**From:** PGE Plan Review [REDACTED]  
**Sent:** Tuesday, May 25, 2021 10:09 AM  
**To:** Le, Thai-Chau  
**Subject:** Re: Notice of Preparation (NOP) for the Wat Khmer Kampuchea Krom Temple Project Draft Environmental Impact Report (C20-021/SP20-024/ER20-147)  
**Attachments:** Initial\_Response\_Letter\_5-25-2021.pdf

**NOTICE OF PREPARATION OF ADRAFT ENVIRONMENTAL IMPACT REPORT FOR THE WAT KHMER KAMPUCHEA KROM TEMPLE PROJECT**

**FILE NO:** C20-021/SP20-024/ER20-147

# RESIDENT'S RESPONSE TO THE: Proposed Rezoning and Special Use Permit at 2740 Ruby Avenue , Project No. C20-012 & SP20-024

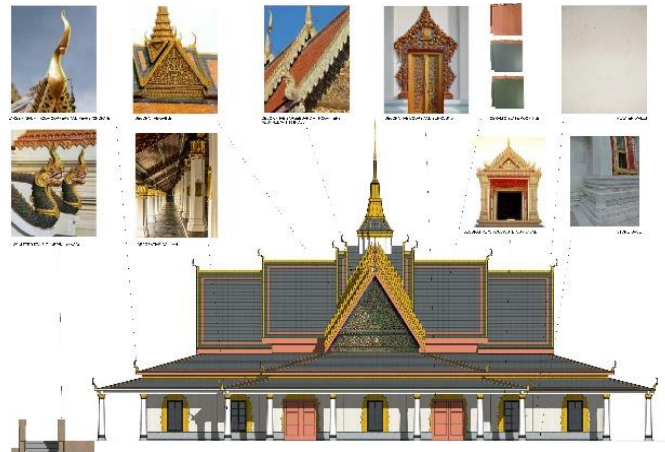
10. A visualization of the proposed temple with respect to the neighborhood, especially the small existing home at 2720 Ruby Ave surrounded on 3 sides by the proposed project, the temple would be **COMPLETELY OVERSIZED**, out of character for this small lot of land. It is also **ESTHETICALLY NON-COMPATIBLE**.

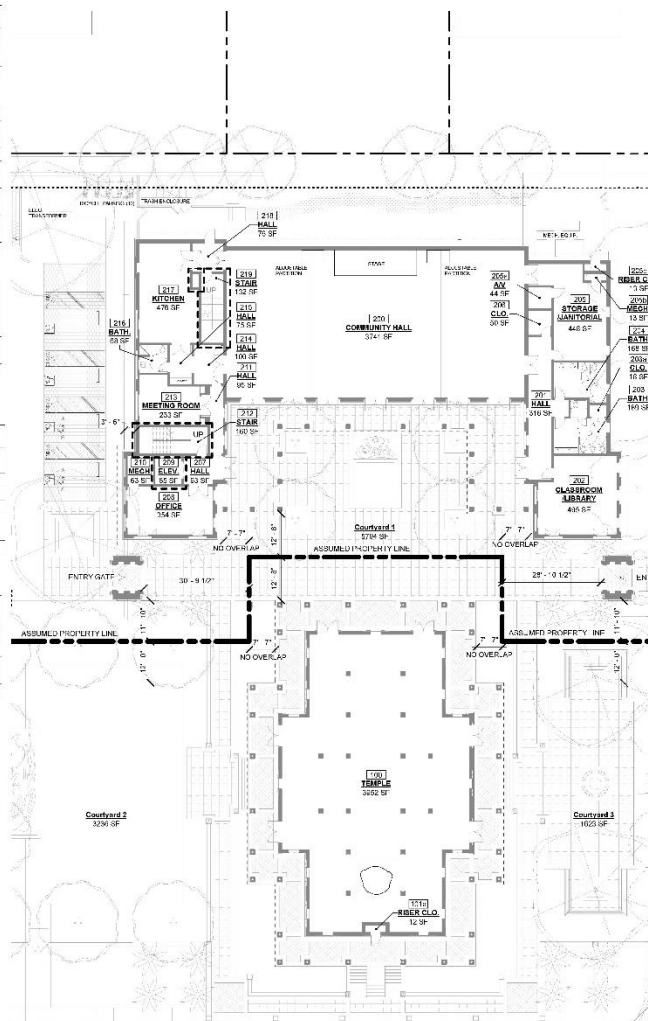
### INCONSISTENT - DECEIVING OCCUPANCY CAPACITY

- 25 visitors weekday, 75 visitors weekend
- Up to only 300 visitor on special event...

**FIGURE 1 – Home directly impacted by MASSIVE Driveway, MASSIVE PARKING LOT, MASSIVE 65 feet Tall Building on 3 Sides**

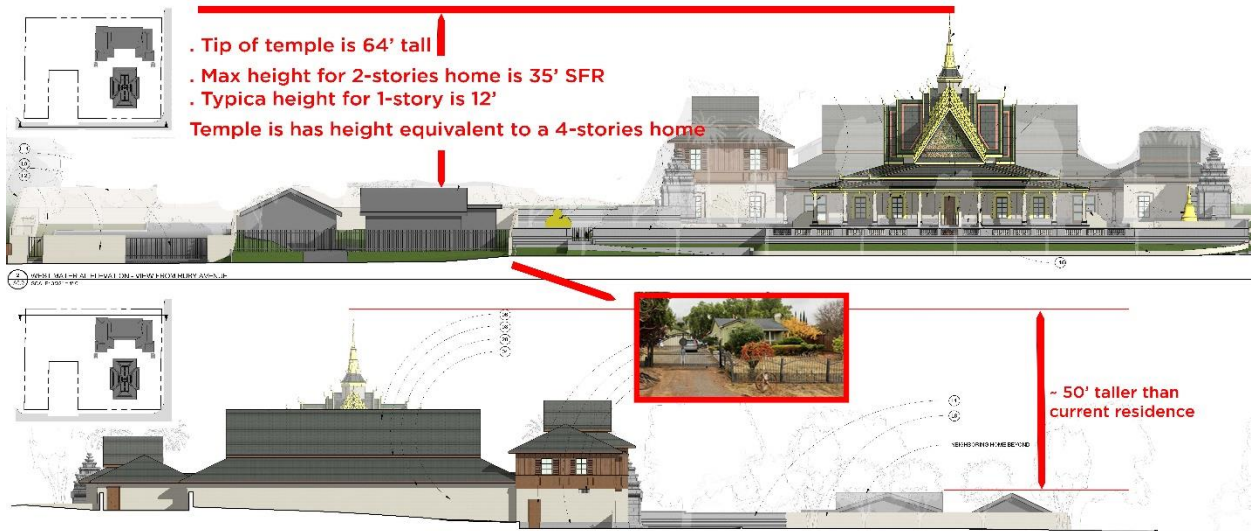
7. Neighbors who are directly next to the projects will be severely impacted! Neighbors in a typical 1500-2500 SF homes will be looking at a **MASSIVE structure** over their fence. The **resident @ 2720 Ruby (See Figure 1)** will be wrapped on 3 sides of their home by a **HUGE entrance into a HUGE parking lot, next to a MASSIVE 65 feet tall building, and GIGANTIC bigger than life garden ornamental scuptures**. **HOW IS THIS PROJECT COMPATIBLE** within a dense Residential Neighborhood?

8. For every **Council Members**, every **Planning Commissioners**, every member of the **planning staffs**, the **lobbist(s)**, the **designer(s)**, **honestly**, would you approve this project if you are the **resident of 2720 Ruby**, and your home will be surrounded by a **MASSIVE driveway, a MASSIVE parking lot, and MASSIVE building that is 65 feet tall** and all the **MASSIVE yard scuptures** next to your fence?

Figure 3 – The project proposes 56 stalls of parking and 15 double-parked spaces that would block 60% of on-site parking stalls. Image is Applicant’s sheet G3.0, “Parking Count Diagram.”

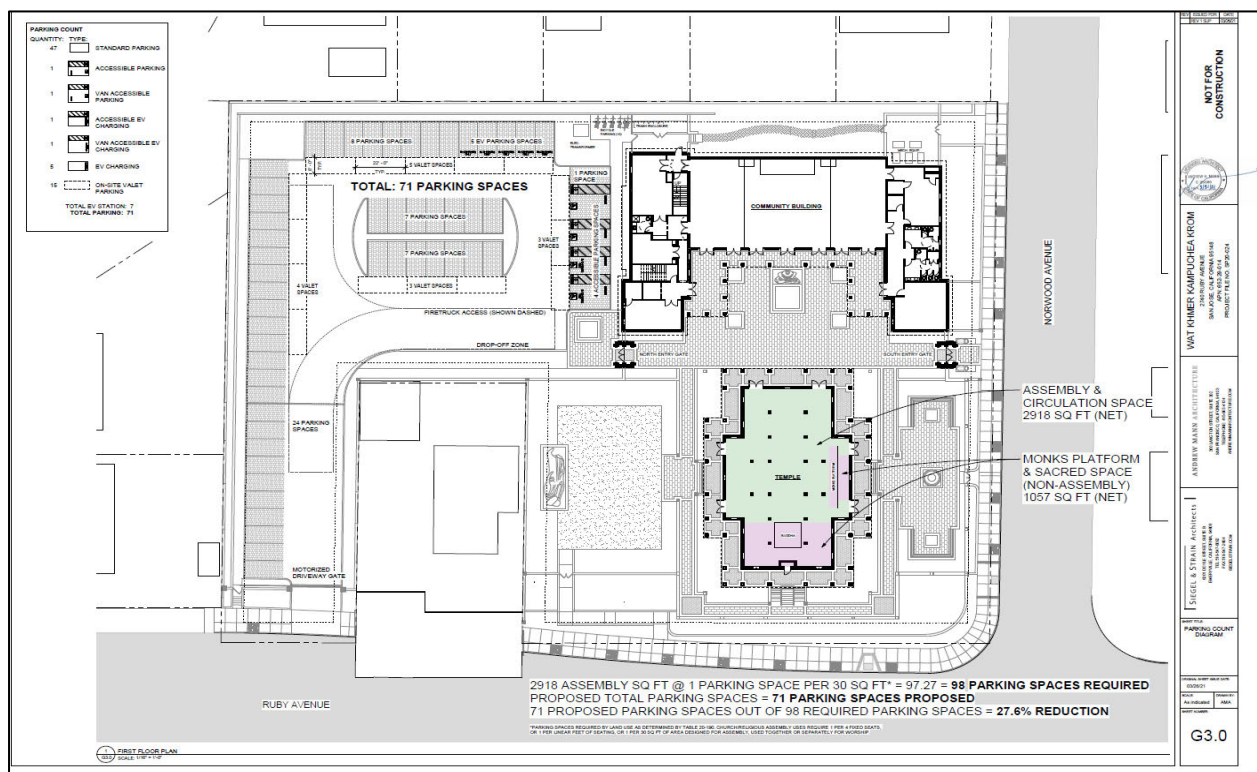
The Proposed Project would provide these 98 parking spaces through a combination of on-site and off-site parking. As shown in Figure 3 below, on-site parking would consist of 56 stalls of parking and another 15 spaces that vehicles would use to double-park. These double-parked vehicles would block 60% of the on-site parking stalls, including stalls dedicated for parking for disabled persons. Though the double-parked spaces are identified as “valet,” no permanent valet is proposed to manage daily use of these spaces. All vehicle trips to the Site would occur via one proposed point of access. All loading/unloading would occur within about 15 feet of the rear of the Tran family home.

Applicant asserts that they may be eligible under the zoning code for an up to a 50% parking reduction<sup>3</sup> based on findings of a traffic consultant study. (Applicant Statement, March 26, 2021, p. 9). If granted such a parking reduction, the applicant would be required to implement a Transportation Demand Management Plan (TDM), and the TDM would be used to manage event parking if applicant anticipated that on-site parking capacity would be exceeded.
